TCAAP Final AUAR and Final Mitigation Plan

July 2014

Appendix A. Response to Comments on the Draft AUAR

1. PROJECT TITLE: Twin Cities Army Ammunition Plant (TCAAP) Redevelopment Project

Figure 7-1. Existing Cover Types
TCAAP AUAR

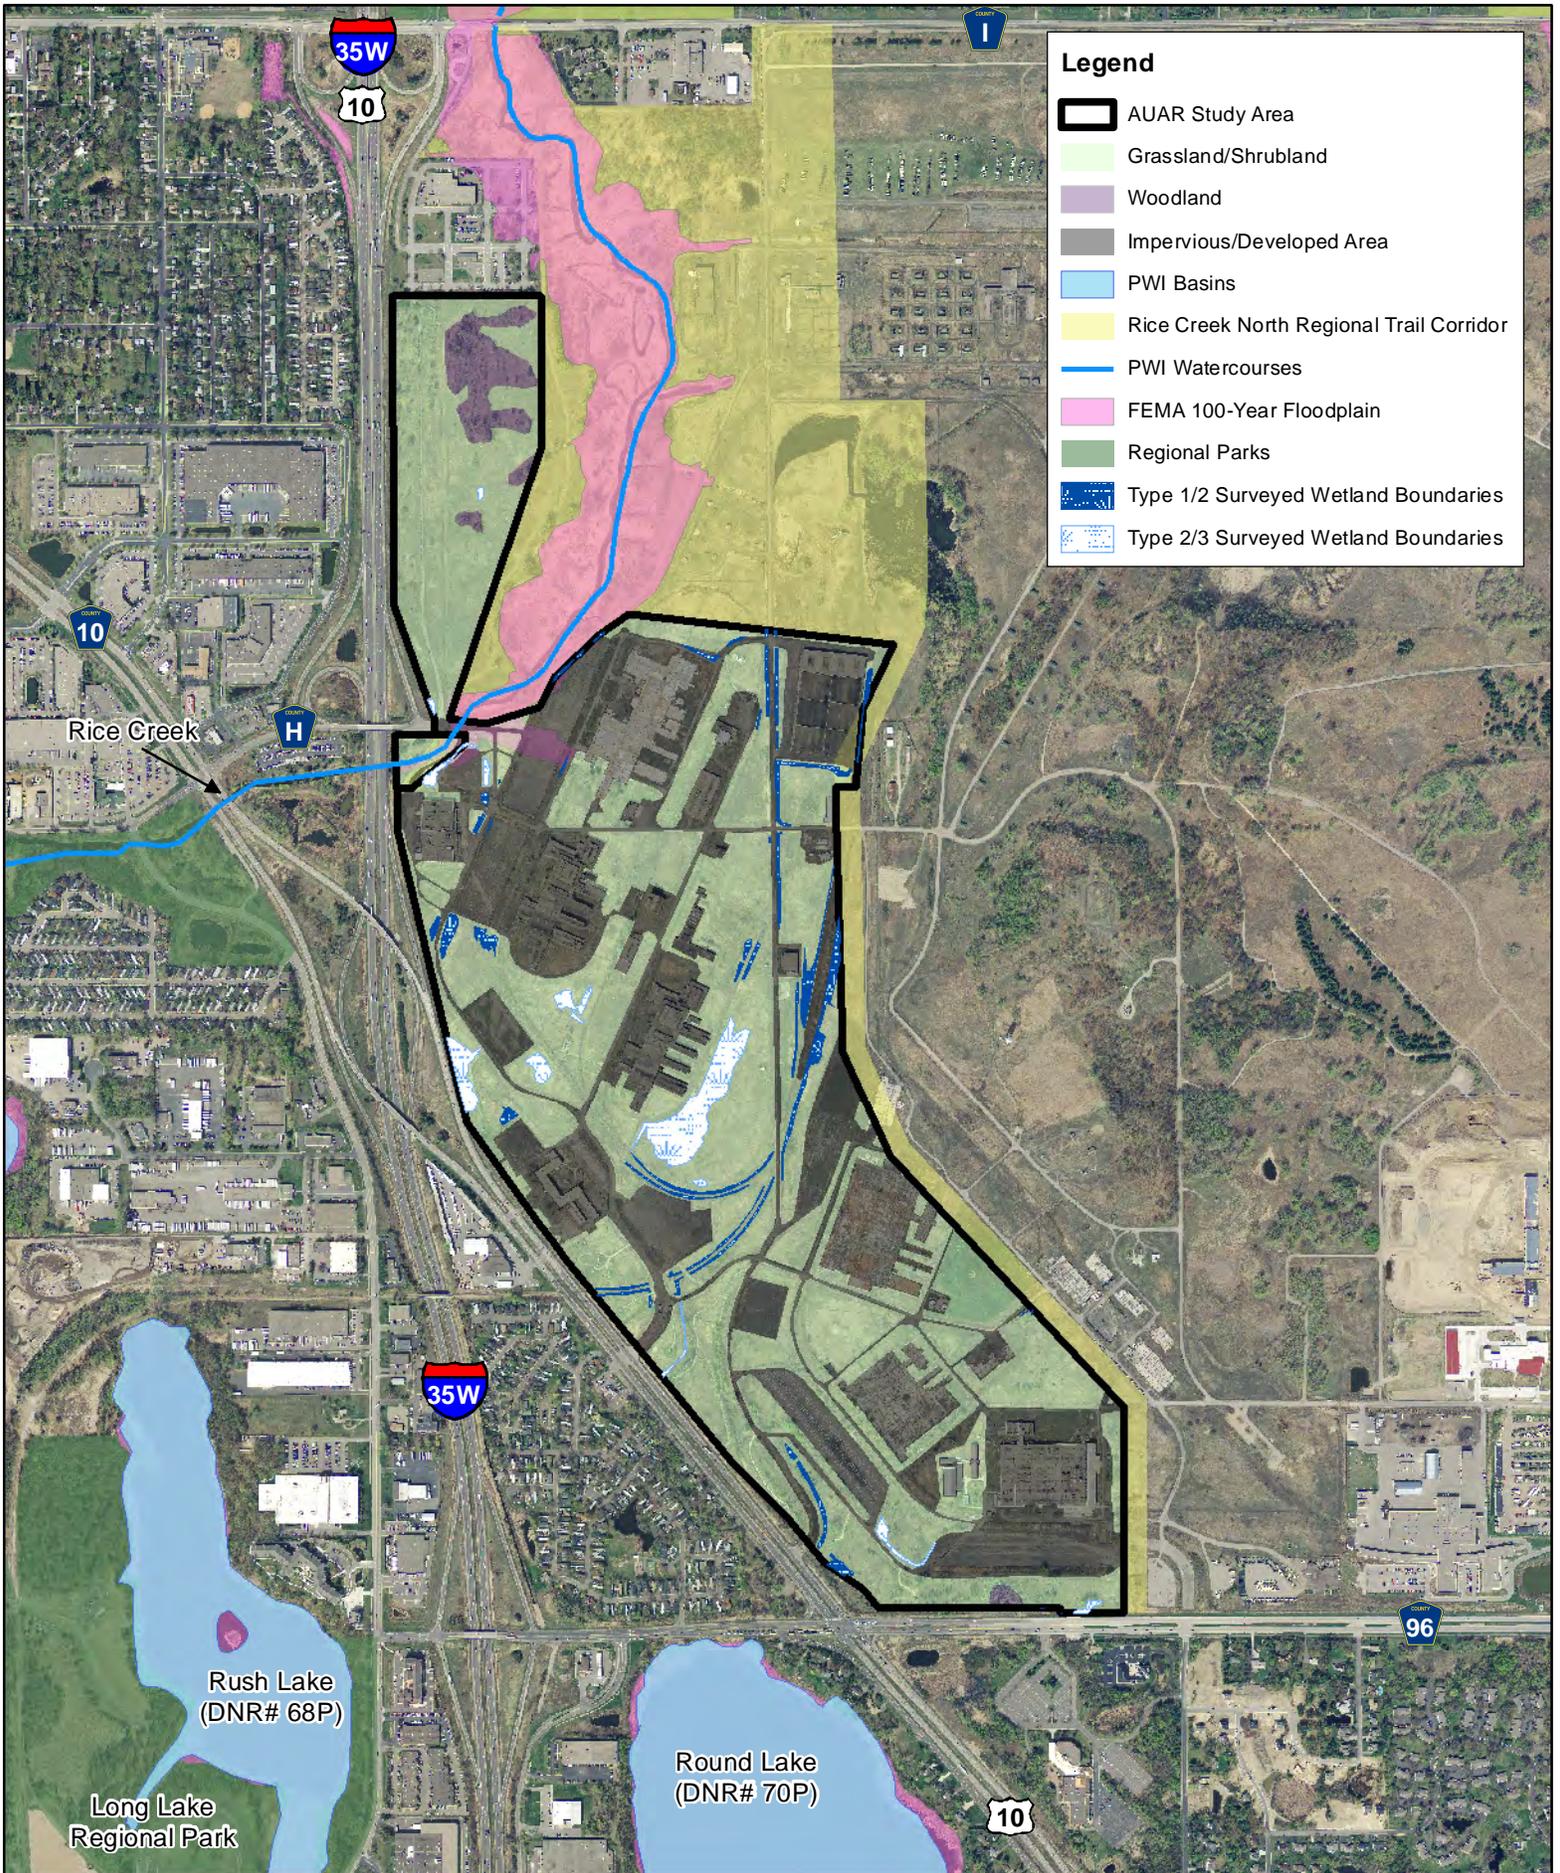
The draft AUAR identifies on Figure 7-1 – Existing Cover Types, the presence of Woodland on the AUAR site. The majority of the remnant woodland areas appear to be present in the northwest portion of the study area bounded by TH10, the MnDOT Facility, and Ramsey County Park Parcels. The document does not describe the type and quality of woodlands present on the site, and the extent to which they will be incorporated into the site's future development. As noted by the DNR in their February 18, 2014 comment letter in the document, much of the northwest portion of the study area (and the County Parks parcels and AHATS property to the east) are within a Regionally Significant Ecological Area, based upon the ecologically significant quality of terrestrial and wetland vegetation in the areas. The Council encourages the City to incorporate an evaluation of the site woodlands in the final AUAR and give consideration to preserving and incorporating as many as possible as an amenity into the stormwater treatment and infiltration system planned for the northwest portion of the study area through density transfer, park dedication, and other means as appropriate.

- I:** The woodland areas identified in Figure 7-1 can be described as areas with scattered woody vegetation with less than 15 percent canopy cover and an understory of smooth brome grass and goldenrod. The woody vegetation primarily consists of small scrubby volunteer trees and shrubs, most less than 25 feet in height, including cottonwood, juniper, box elder, Siberian elm, and Russian olive. This cover is indicative of a disturbed site that has regenerated with opportunistic plant species. The City's development guidelines will encourage the preservation of open/green space and infiltration where feasible.

Figure 18-1. County Road H and I-35W Interchange Improvements
TCAAP AUAR

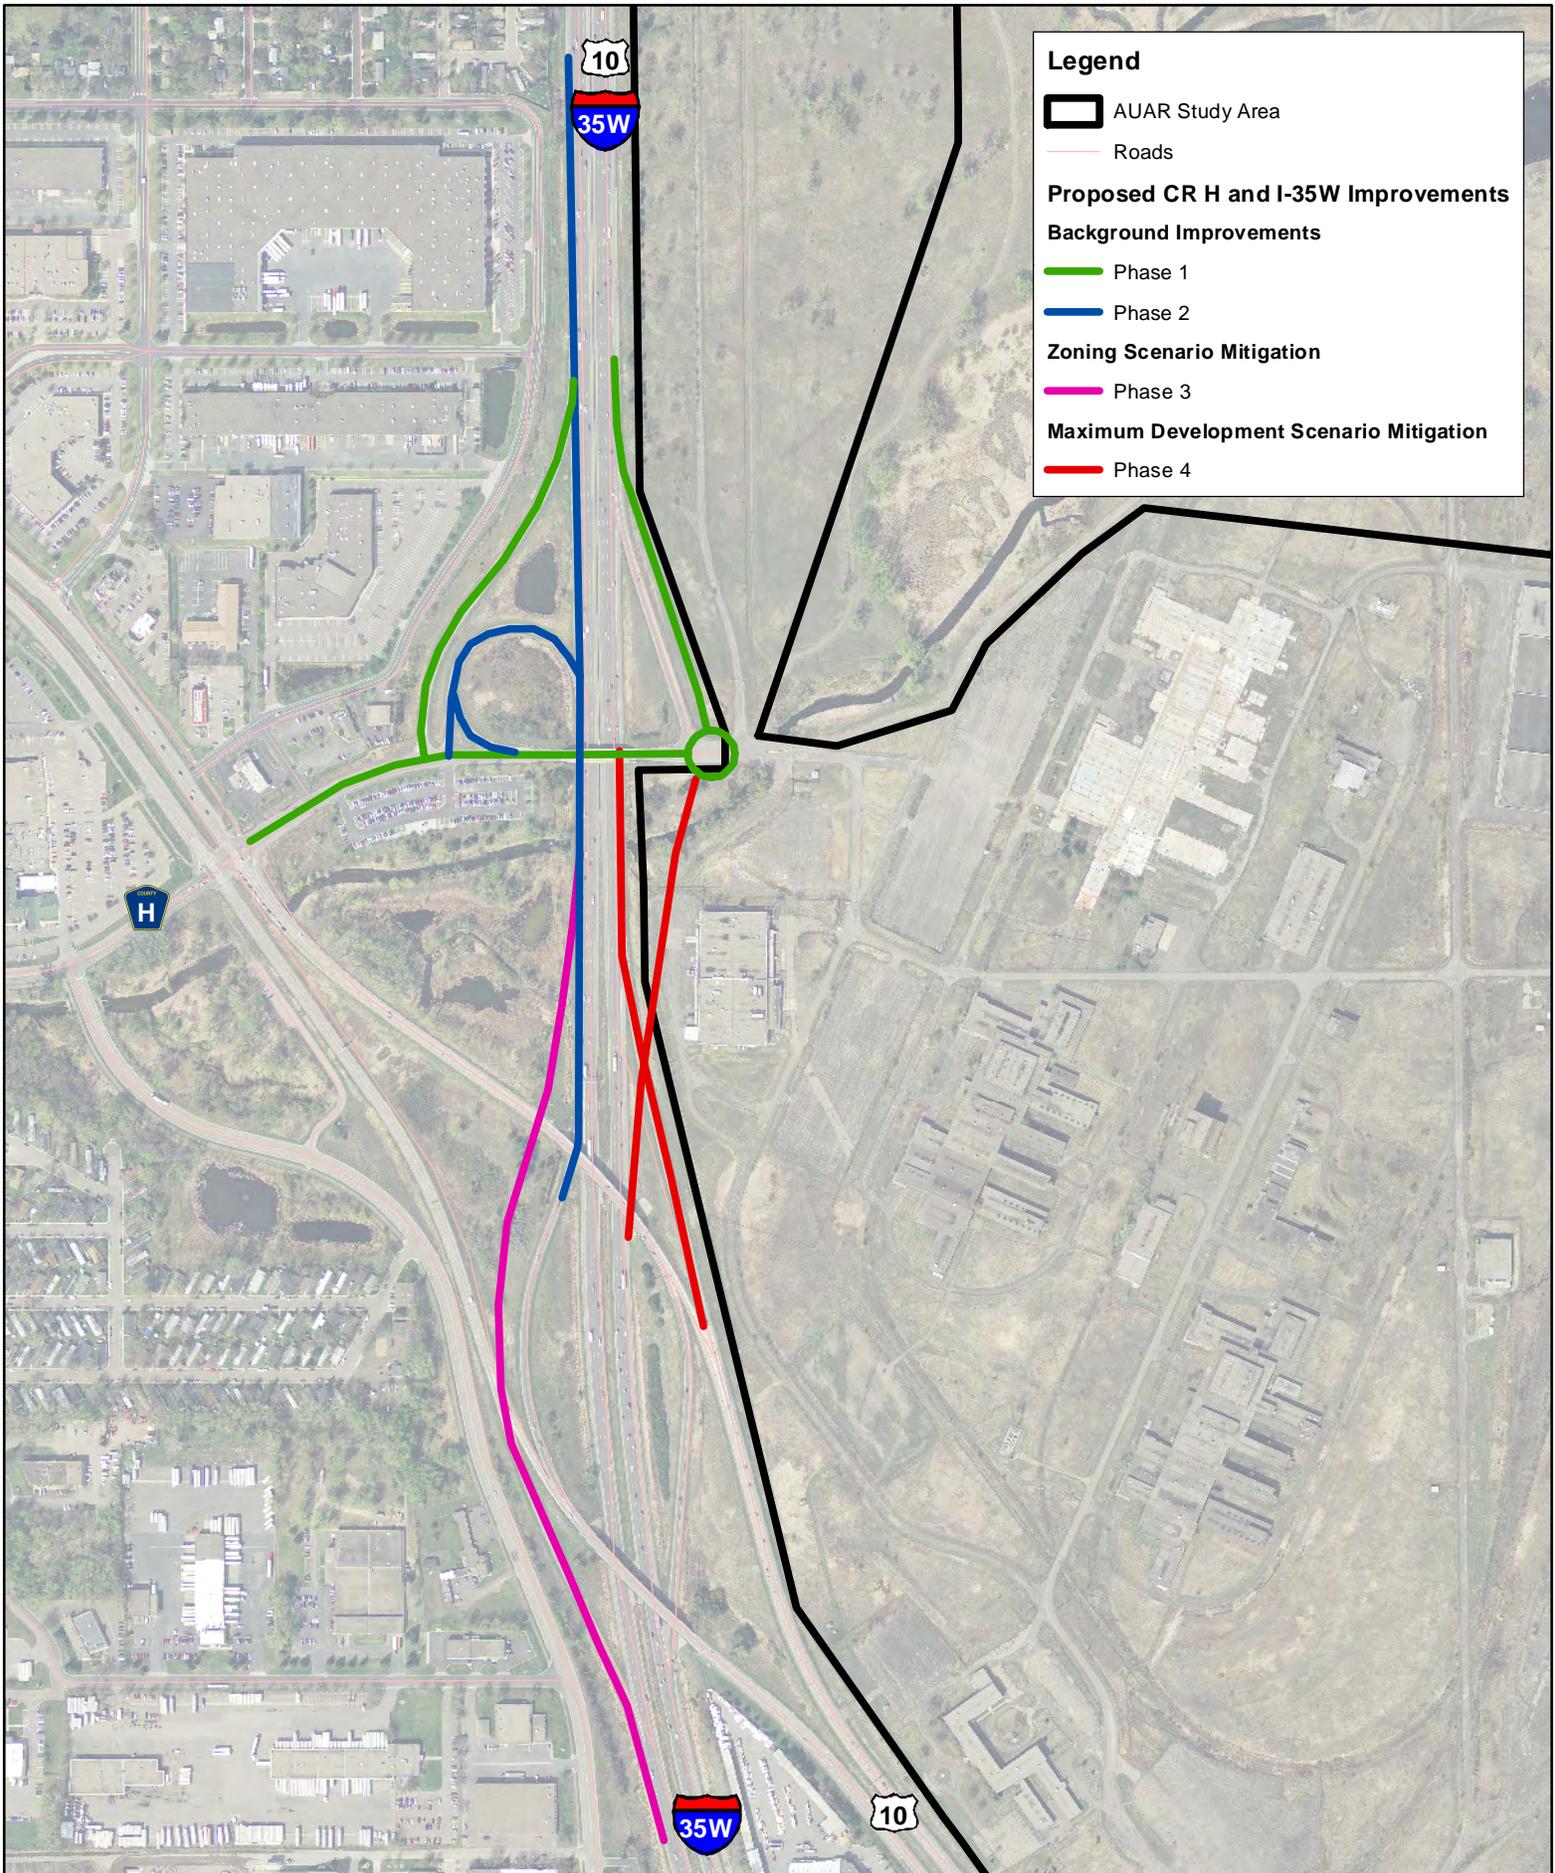
D | County Road H/35W interchange – 2016 rebuild. Will phases 1-4 (figure 18-1) come in succession until the total project is done or on separate start and completion dates? If not in succession then phase 4 should be included with phase 1, because major construction would be on the same side of 35W. Also a traffic lane should connect Hwy 10 north with the H roundabout.
